**MEMORANDUM**

DATE: June 9, 2015

SUBJECT: BZA #19011 – 129 Varnum Street, NW

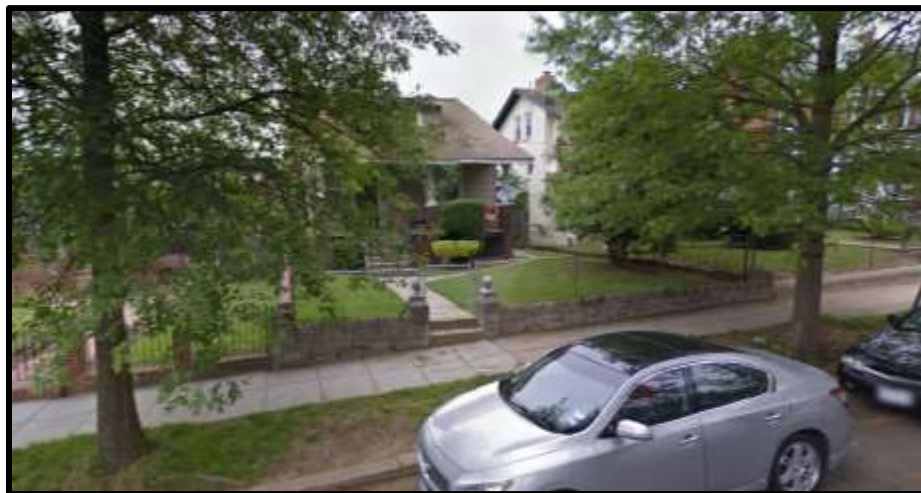
The applicant proposes a seven-unit multi-family building which would abut the front building restriction line (BRL). The BRL is located approximately five feet in front of the existing front porch, and it appears that all homes along this block were set back from the BRL the same distance. A new building built out to the BRL would not be visually compatible with the remainder of the block, and the proposed building should be set back to be in line with the other homes. See the map below showing the BRL and existing building footprints.
